**Snohomish County  
Planning and Development Services**

July 29, 2015

Subject: Point Wells Submittal Drawings—Request for Clarifications

**Figure 1 – Typical Tower Floor Plan**

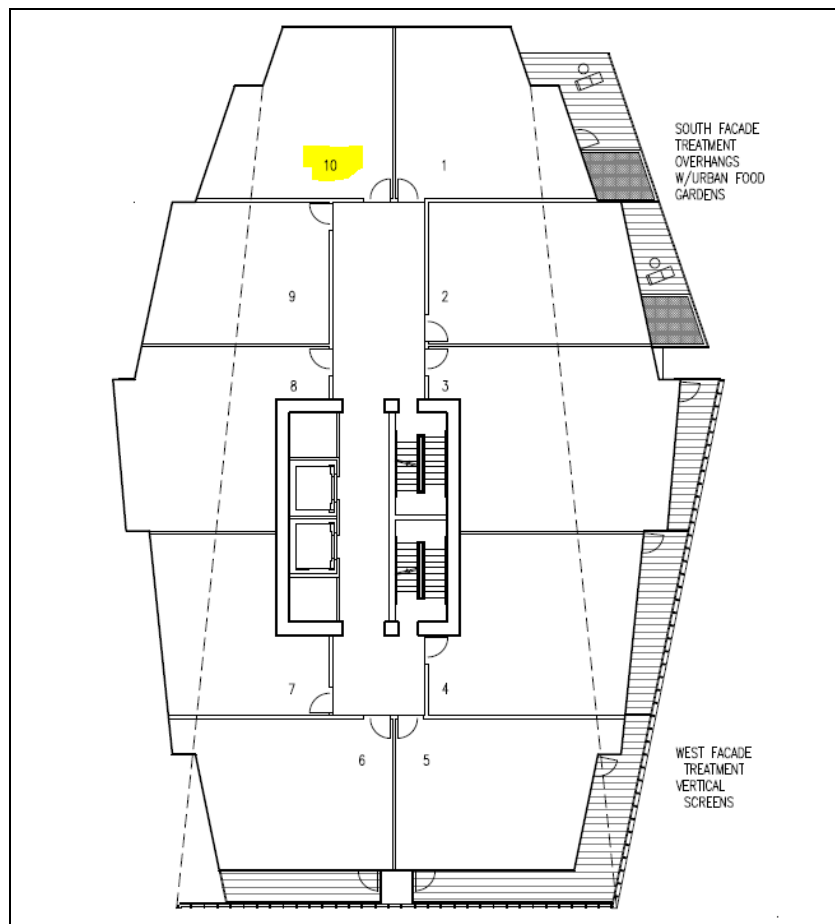
Figure 1 is a portion of Sheet A-300 that shows a typical tower floor plan with 10 units per floor.

The data tables, building elevations and floor plans need to be consistent. If the typical tower floor in the Central Village will have more than 10 units/floor, as implied in Figure 3, then the typical floor plan on sheet A-300 will need revision to reflect this. Alternatively, the table on sheet A-102 could be updated to reflect 10 units per floor. This applies to all towers in the Central Village.

**Figure 2 – Footprint for Building CV-T7**

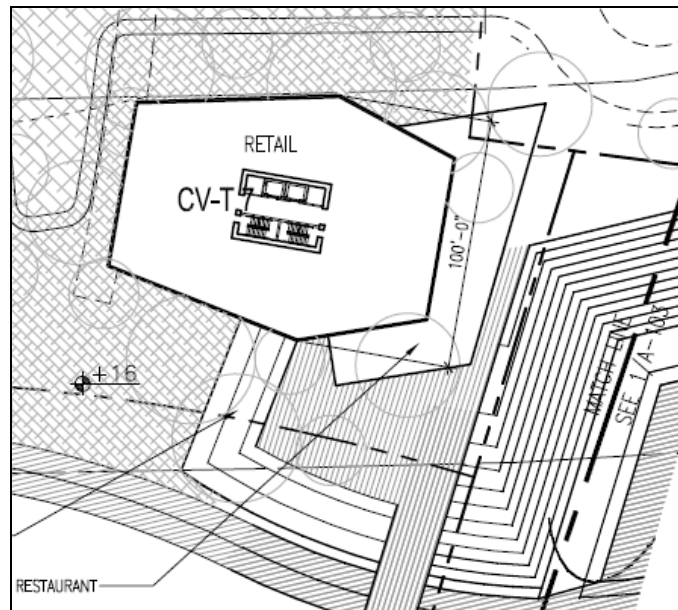
Figure 2 shows from a portion of Sheet A-102 that CV-T7 is clearly a match for the building with the typical floor plan shown in Figure 1.

Figure 4 – Building NV-T2 from Sheet A-101 (Unit Numbers Added)

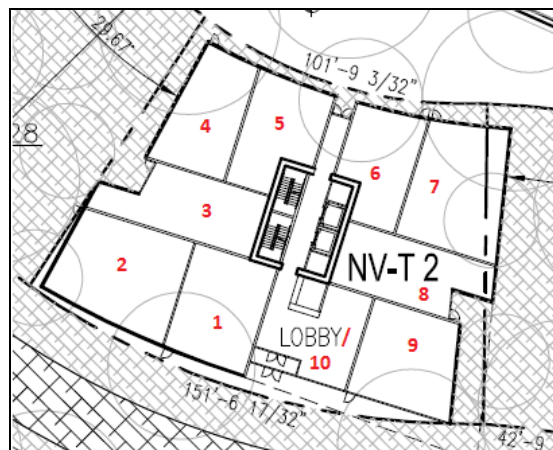
Tower unit counts in other phases need clarification as well. Building NV-T2 in the North Village is an example (see Figure 4, below). This building would appear to have 10 units on each of its upper floors (and only nine on the first floor due to a need for lobby space). With 16 floors proposed, this would suggest 159 units in the building based (10 units per floor minus one unit for the ground floor lobby). However, the data table on from the same sheet (Figure 5, below) would suggest however that the typical floor would have more than 12 units (195 units/16 floors = 12.2 units/floor).

The DEIS will require new sheets detailing the typical tower plans for the North Village, South Village, and Upper Plaza. In addition, please clarify whether the intent of the floor schematics on Sheet A-101 (Figure 4) is to represent the ground floor or upper floors of the towers. The upper floor plans must be different from what appears on Sheet A-101 because only units 1, 5, 6, and 10 have access the elevator and stairs.

Figure 7 – Buildings CV-L1 and CV-L2 from Sheet A-102

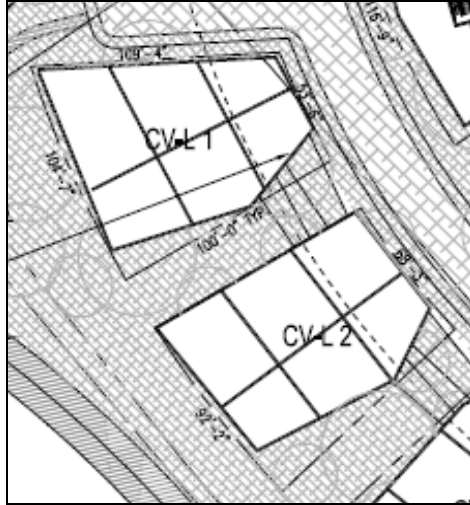
The discussion on townhomes above, however, does not match with how the area plans for each phase depict the buildings and how the units per building are calculated. For instance, Figure 7, next page, appears to show a six-unit design for buildings CV-L1 and -L2. Yet, the data table (Figure 8, also next page) shows 14 units per building. Are these 2-story buildings going to have multi-story townhouse units as suggested by the term and elevation drawing or will the units be stacked flats as suggested in the data tables? Further, either the floor diagrams and/or the data tables need revision for internal consistency on the submittal drawings. If the units in these buildings are to be stacked flats, what buildings does Figure 6 depict?

**Figure 10 – Typical Floor Plan for Midrise Buildings from Sheet A-301**

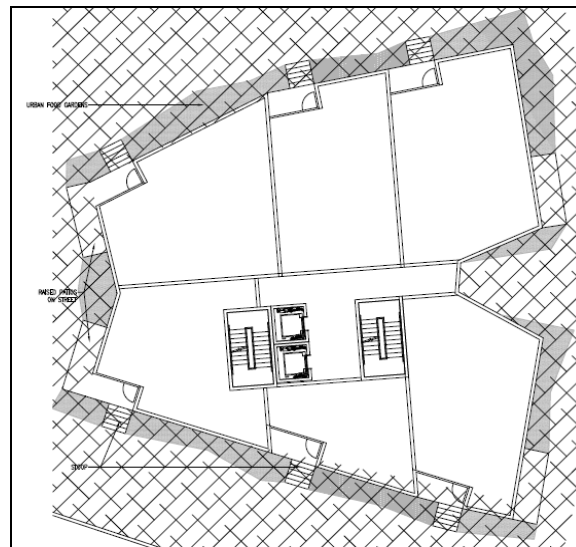
Figure 10, below, shows a typical floor plan for midrise buildings with six units around an elevator core.

Based on Figure 9, we would expect the typical building in Figure 10 to contain 18 units total (units 1-6 being townhomes on floors 1 and 2, units 7-12 being flats on floor 3, and units 13-18 being smaller flats on floor 4). This expectation, however, is not what appears on the data table

**Figure 12 – Building Area vs Leasable Area Illustration and Questions from Sheet A-300**

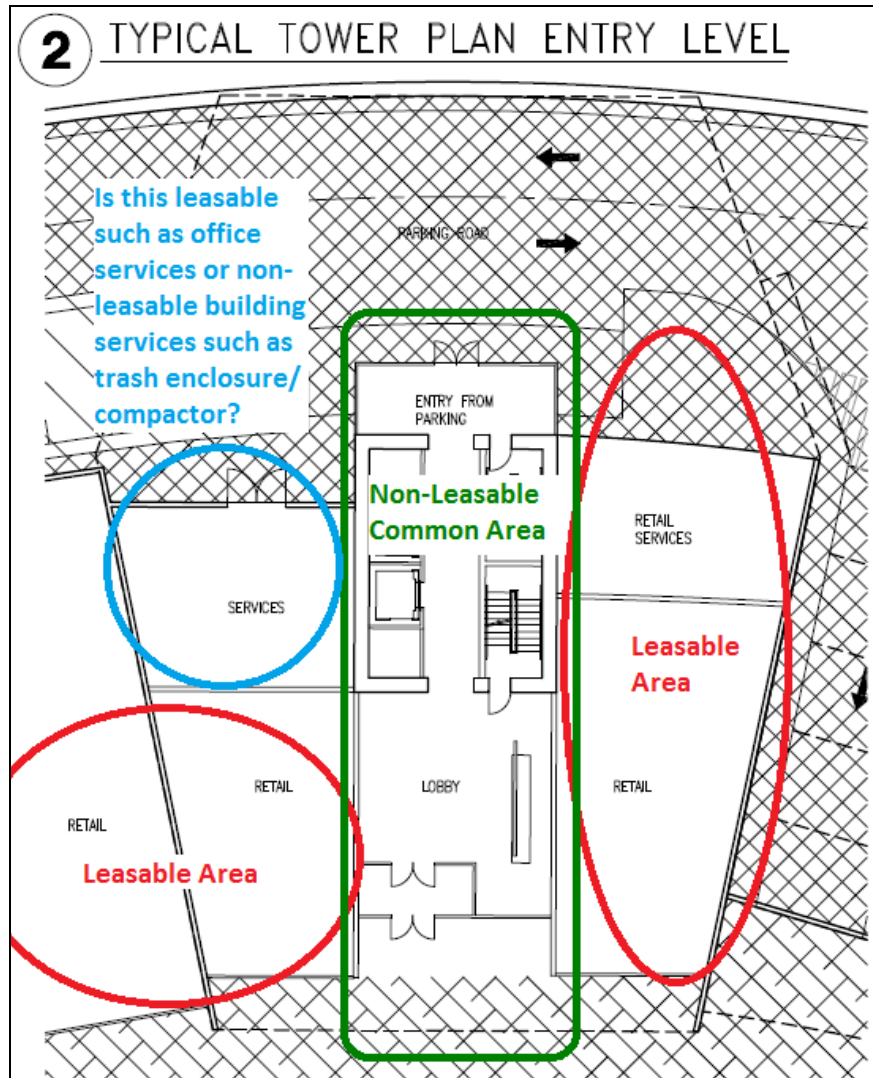
The leasable area is the basis for trip generation in the traffic modeling. Leasable area is the building area minus things like lobbies and elevator space. Please revise existing drawings and add new drawings to identify the square footages and uses proposed for non-residential building areas, clarifying certain areas such as shown in Figure 13 below.
